Re: 26-42 Eden Street, Arncliffe NSW

Our Ref: A101021.0210.LTR1.v1f
Date: 15 September 2021

ADE Consulting Group Pty Ltd (ADE) has been engaged by Billbergia to provide further information regarding groundwater management in response to queries raised by the Department of Planning, Industry and Environment (DPIE) for the proposed development site located at 26-42 Eden Street, Arncliffe NSW (the site). The specific comments ADE has been requested to provide further information on are:

Figure 1 – Location of groundwater dependent ecosystems in relation to the Site (adapted from spatial-portal.industry.nsw.gov.au).

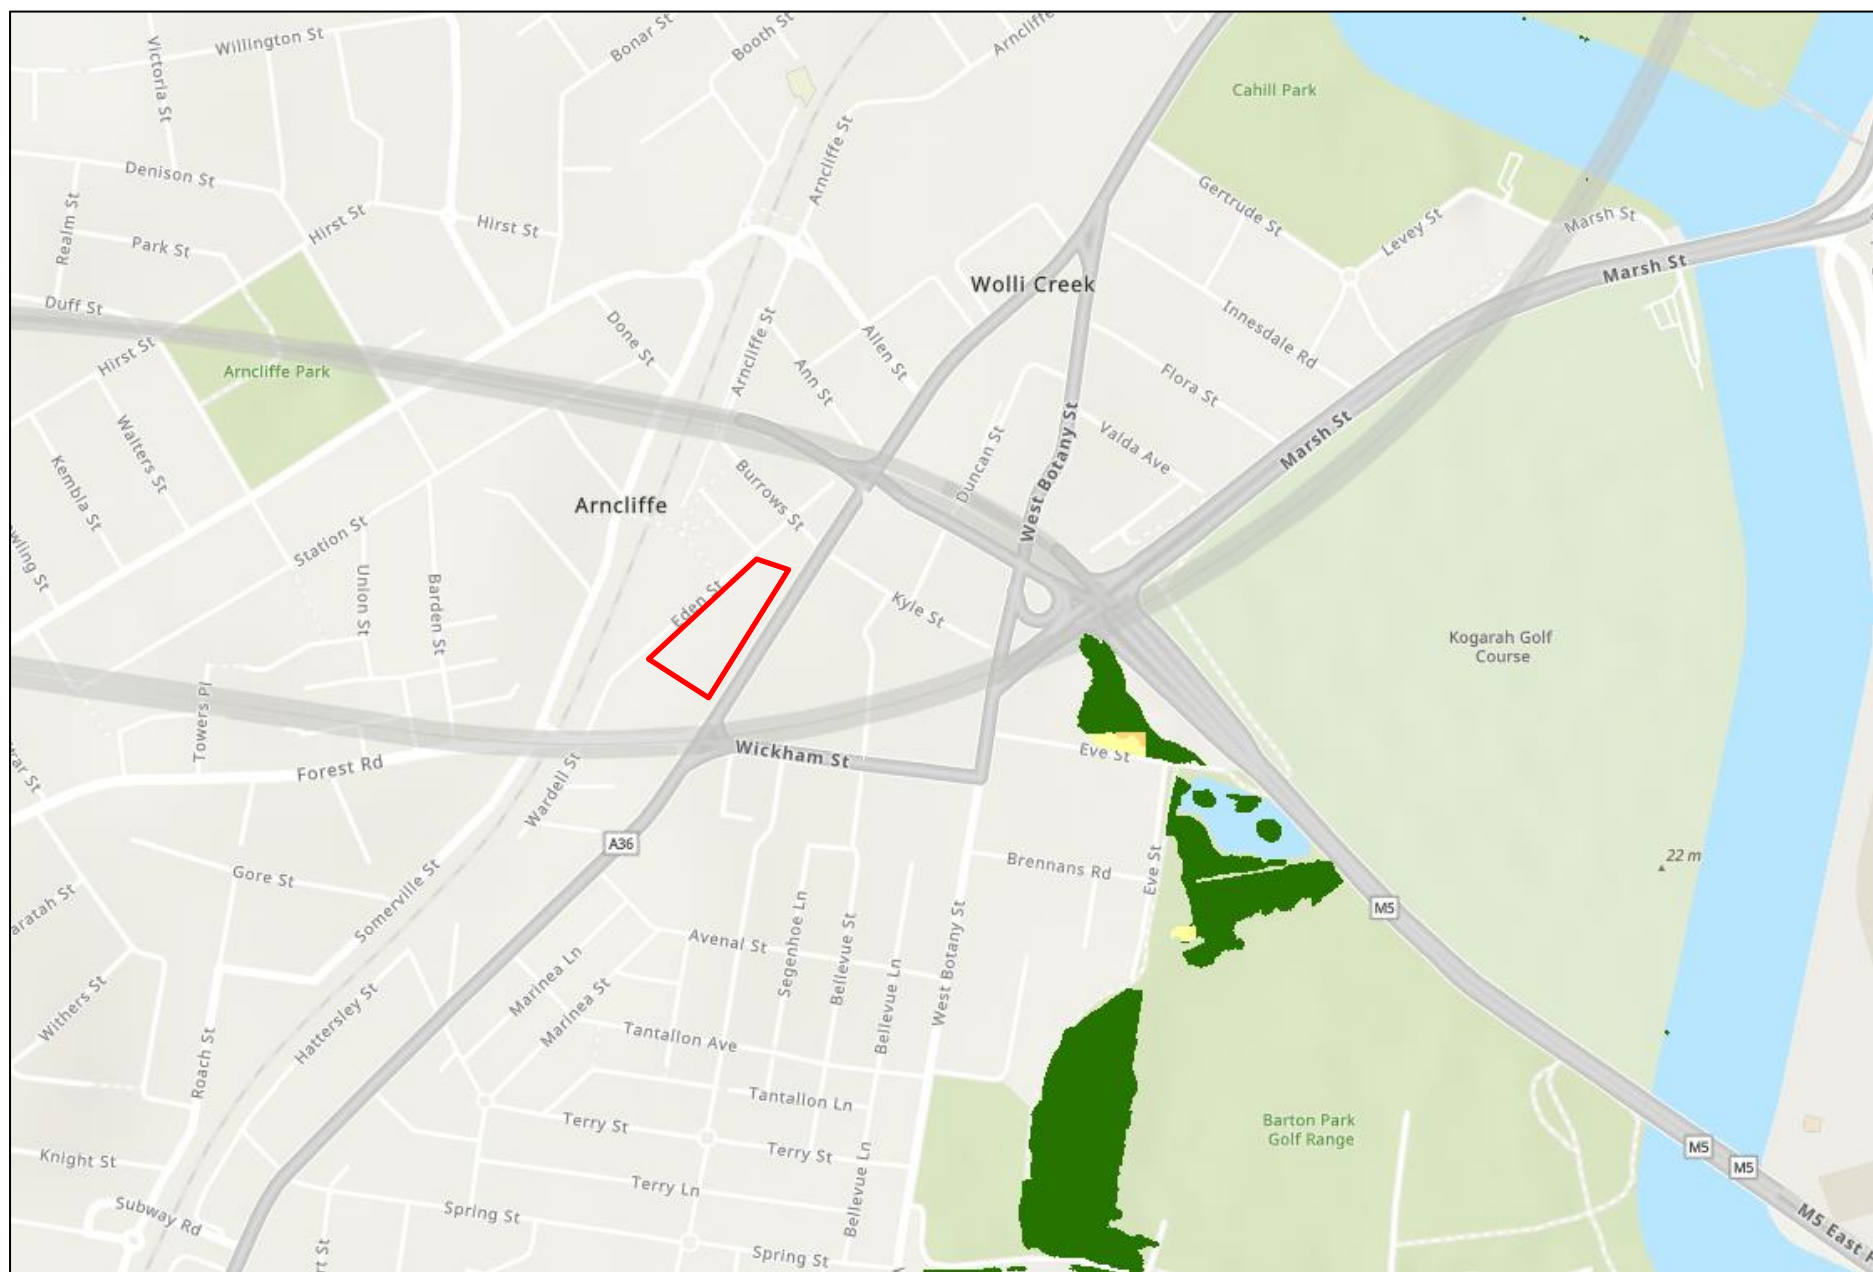
A review of available mapping for groundwater dependent ecosystems (GDE) was undertaken as part of this review and is shown in Appendix A – Figures. The maps indicate that the closest potential GDE is located approximately 400-500 m to the east of the site. Considering the low groundwater flow within the Hawkesbury

sandstone ADE considers it unlikely that the proposed development will have an adverse effect on GDEs.
